SUBJECT: COMANCHE PEAK NUCLEAR POWER PLANT, UNITS 3 AND 4
DOCKET NUMBERS 52-034 AND 52-035
RESPONSE TO REQUEST FOR ADDITIONAL INFORMATION NO. 3183

Attachment 1. Response to Request for Additional Information No. 3183 (CP RAI #88)

SRP SECTION: 13.03 - Emergency Planning

Figure J-12. Evacuation Time Estimates
Scenario 12, Region R03 (Entire EPZ)

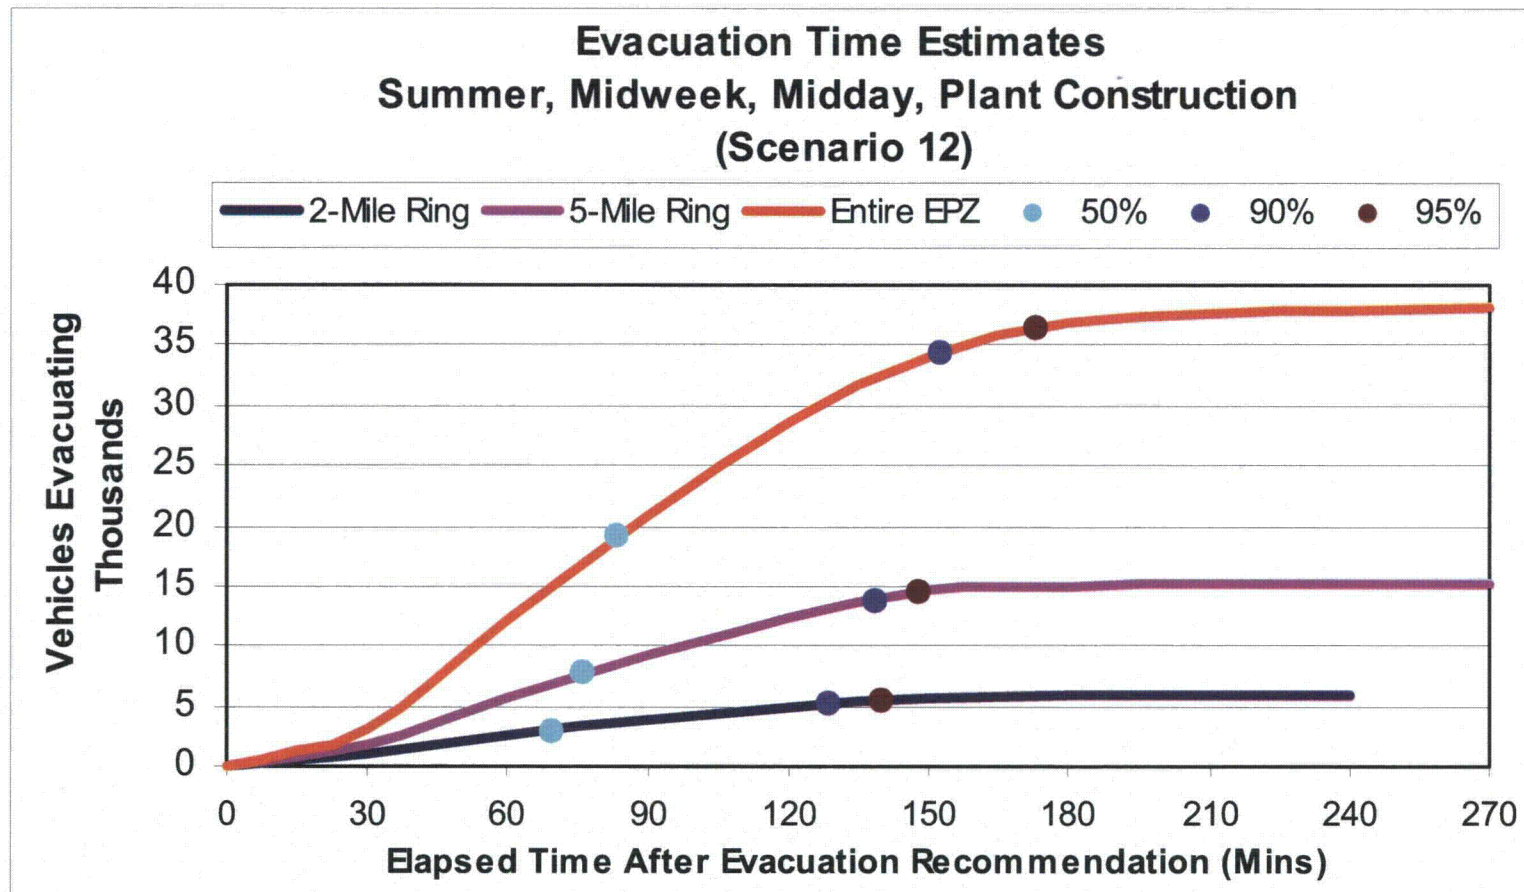
- Add Figure J-13, "Evacuation Time Estimates, Scenario 13, Region R03 (Entire EPZ)."
- Update time estimate on pages 7-7 through 7-14
- Update time estimate on pages J-4 through J-11
- Update time estimate on pages ES-10 through ES-13

Figure J-13. Evacuation Time Estimates Scenario 13, Region R03 (Entire EPZ) will be added after this figure on new page J-26.

This Figure Replaces Figure 6-1 in Section 6
RAI No. 3183
13.03-22

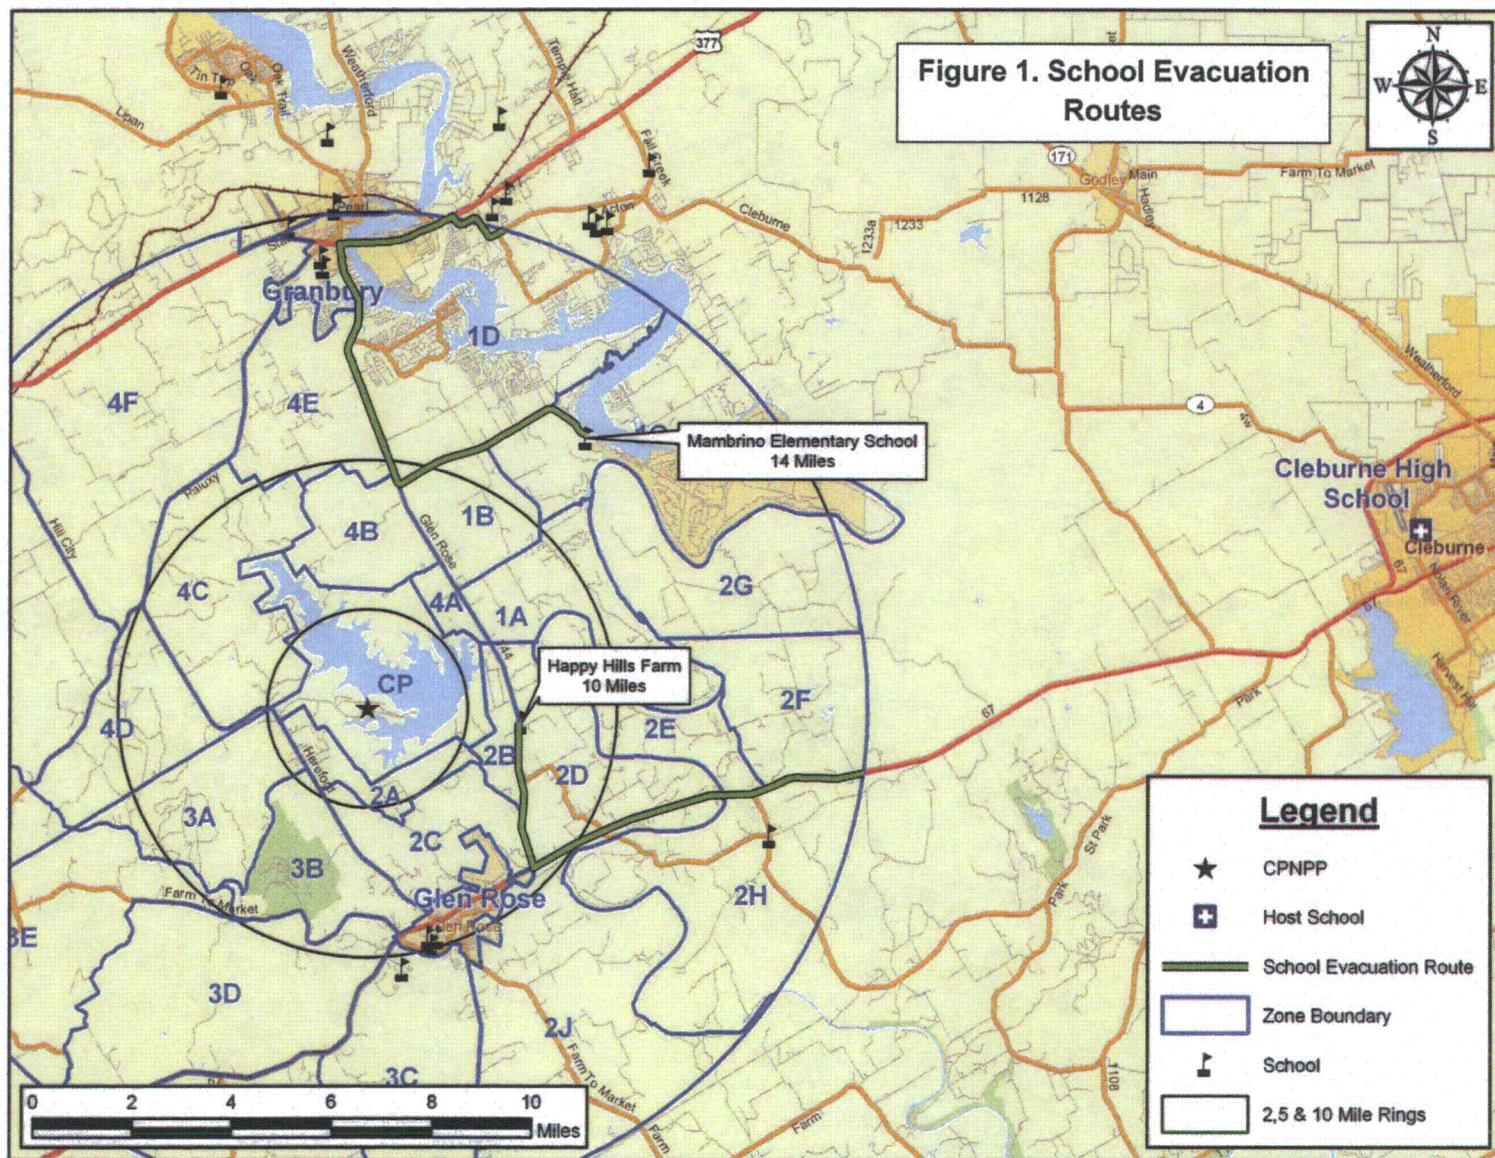
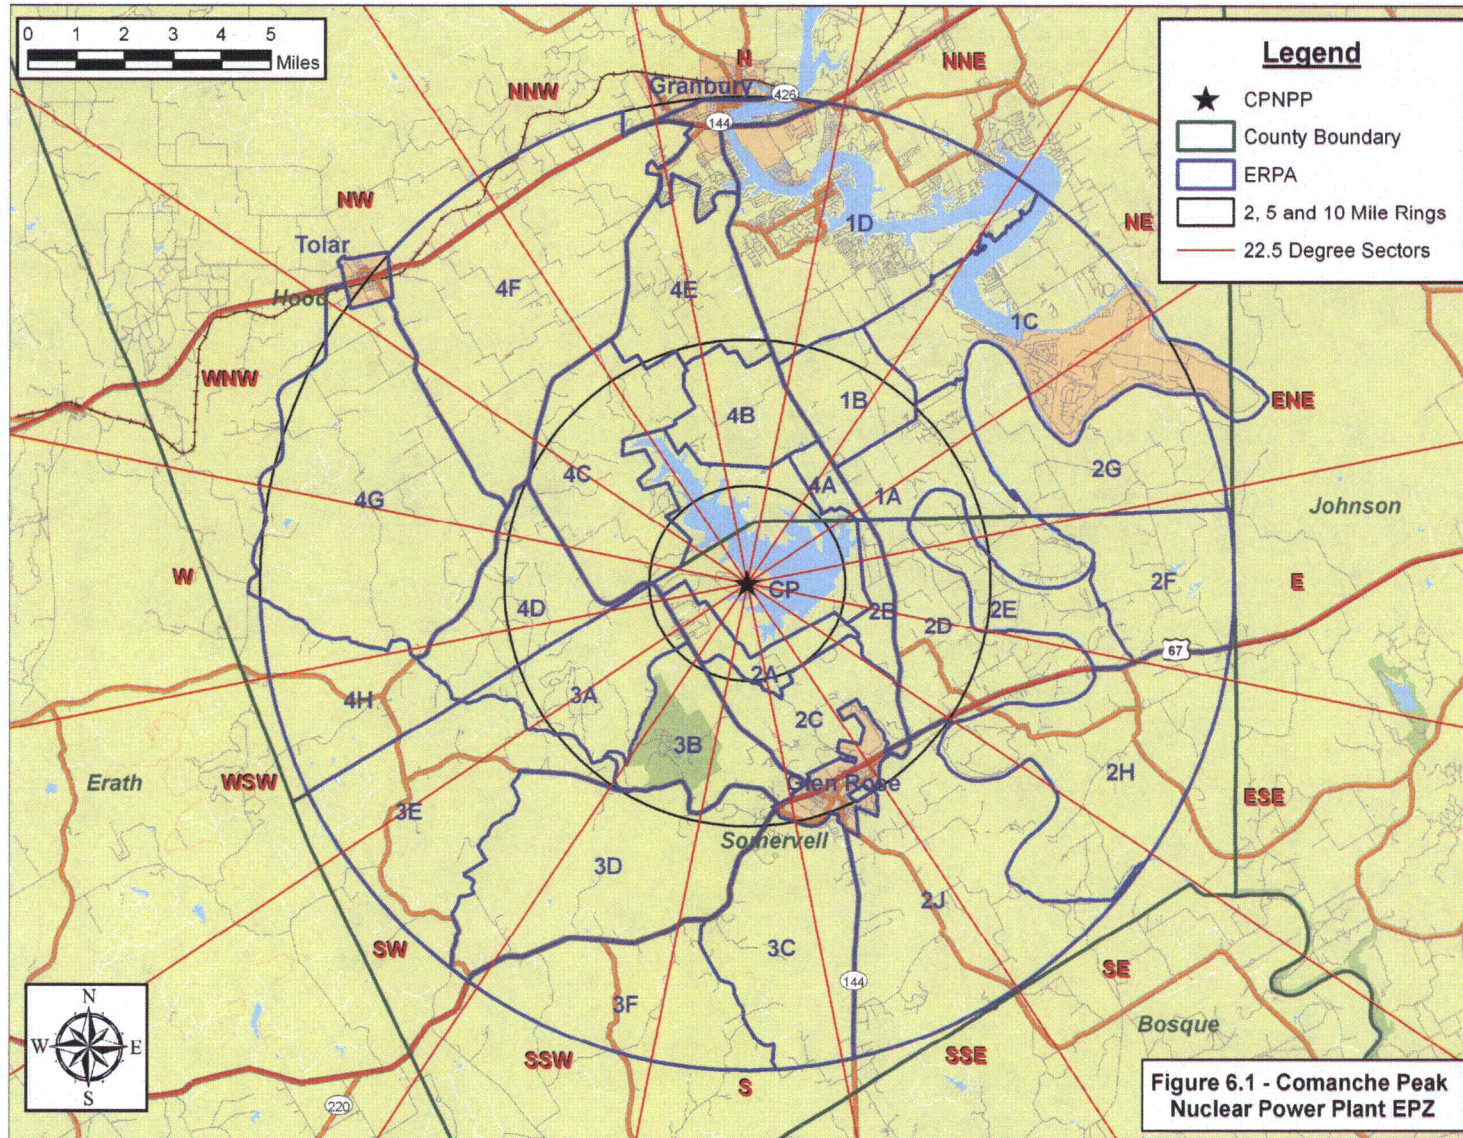
- F. As requested in the RAI, Figure 6-1 will be revised to include 22.5 degree sector lines and will be included in a future revision of the ETE. A revised version of this Figure is included with this RAI response.
